**GENERAL DYNAMICS**

Inter-Office Memo

TO: R. G. Hill  
XC: J. Brummans, T. Offer, J. Ruma  
SUBJECT: Water Ingestion - Mississippi National Guard  
REFERENCE: RGH/86-356 Correspondence Dated 01 July 1986  
ENCLOSURES: (1) Trip Report  
(2) Engineering Work Directive

GENERAL DYNAMICS  
LAND SYSTEMS DIVISION  
TRIP REPORT

FIG 1

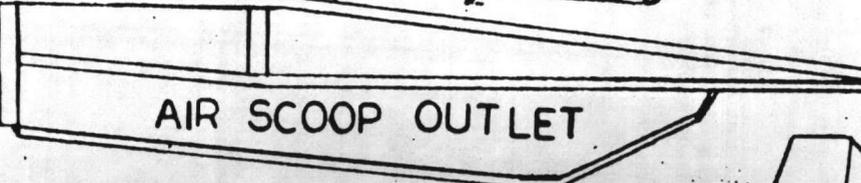
- a. The Donaldson precleaner (Fig. 1) may not have as much water falling on to it as the PLM precleaners do (Fig. 2), due to its higher top surface relative to the air scoop outlet.
- b. The Donaldson precleaner may be able to extract greater amounts of water due to different vortex tube design.
- c. The Donaldson precleaner assembly has a screen, that PLM precleaner does not. This may cause the water to splatter, allowing increased water extraction.

FIG. 2

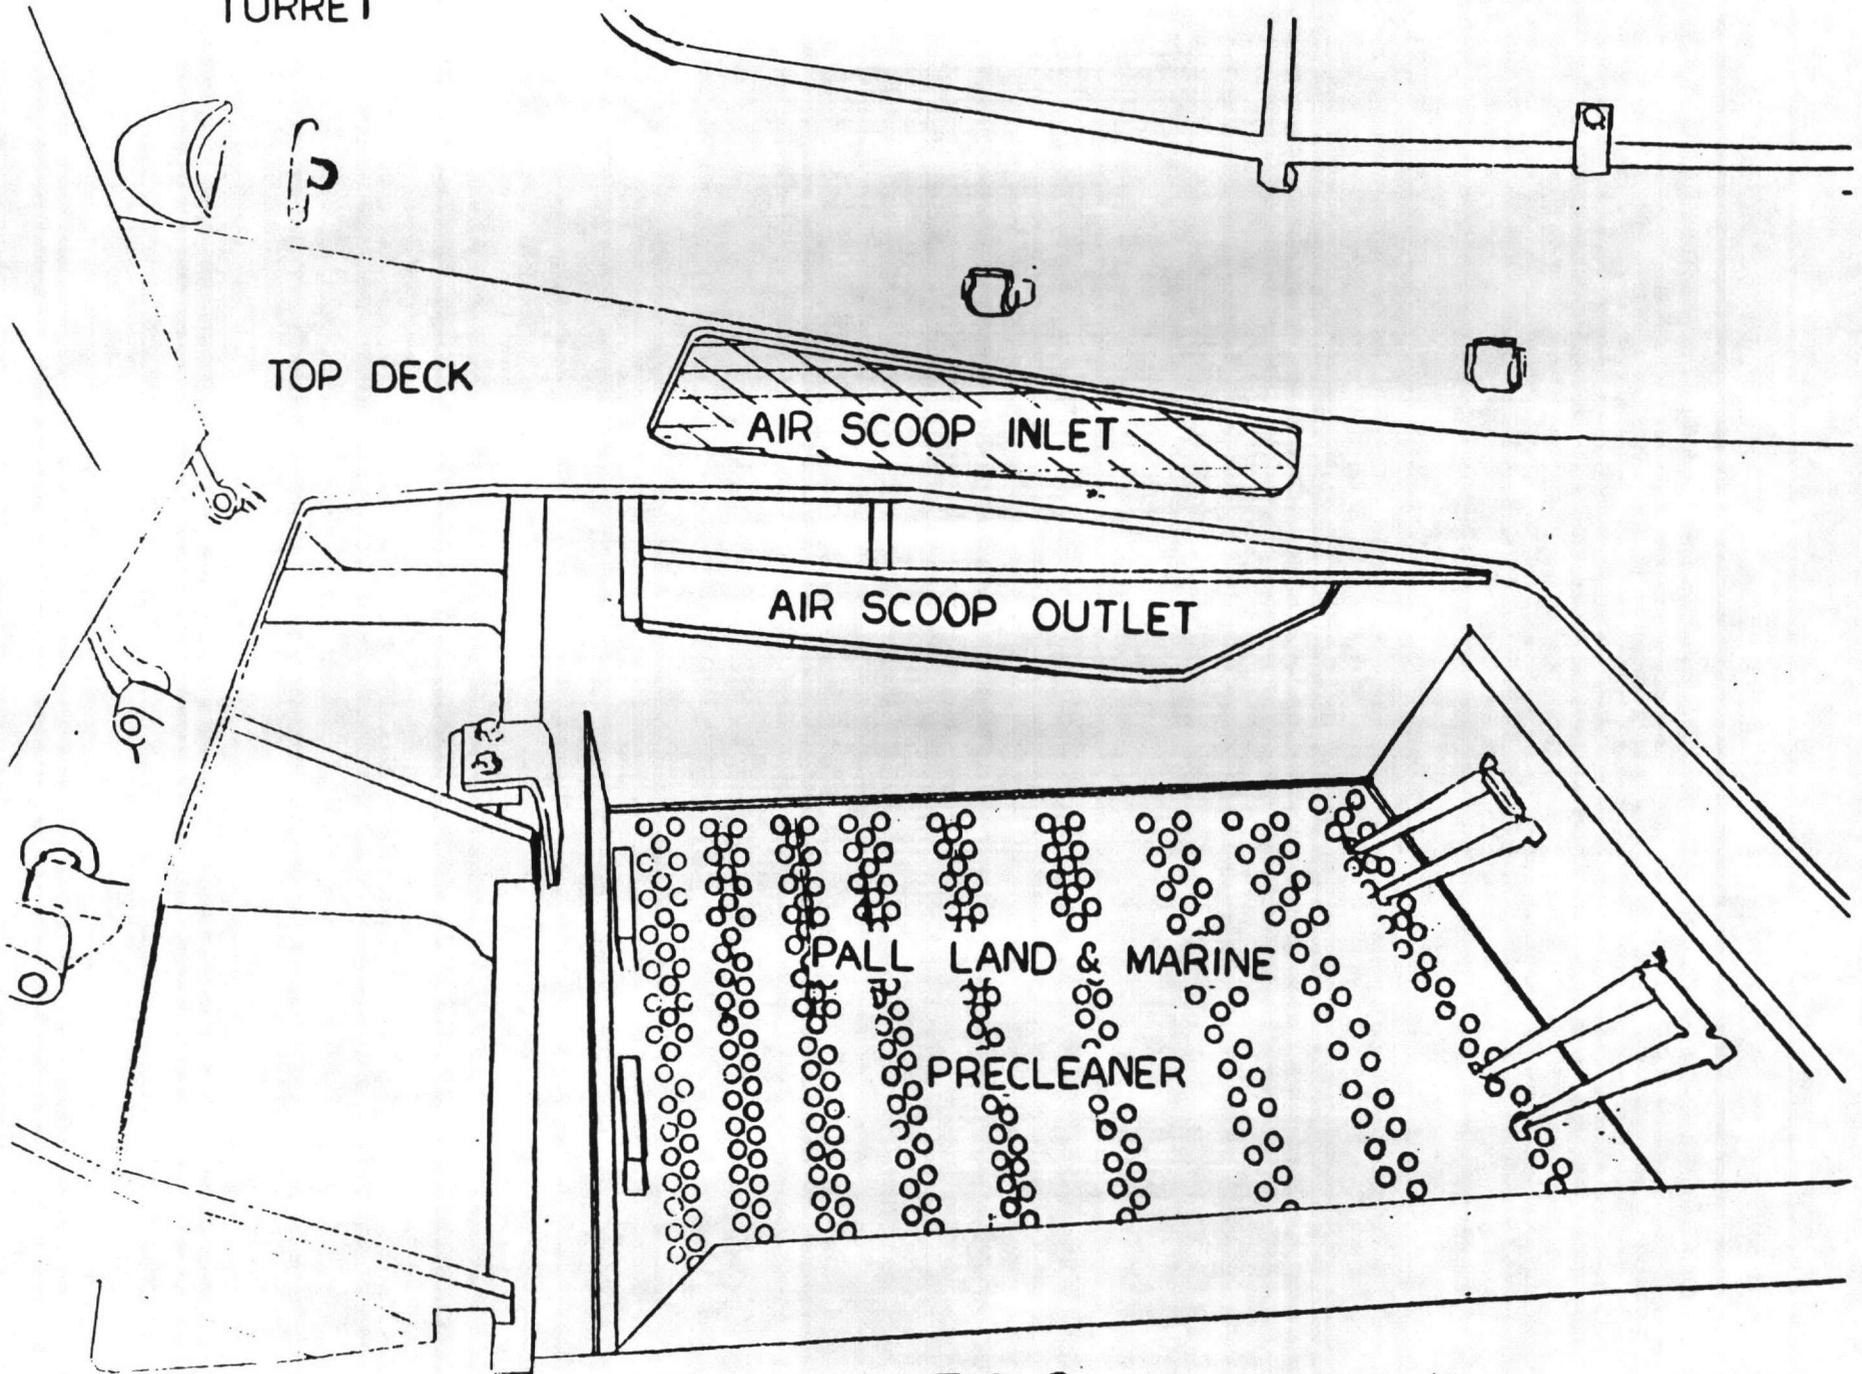
The modified PLM precleaner would have a strip of material added to match the Donaldson precleaner height at the air scoop outlet.
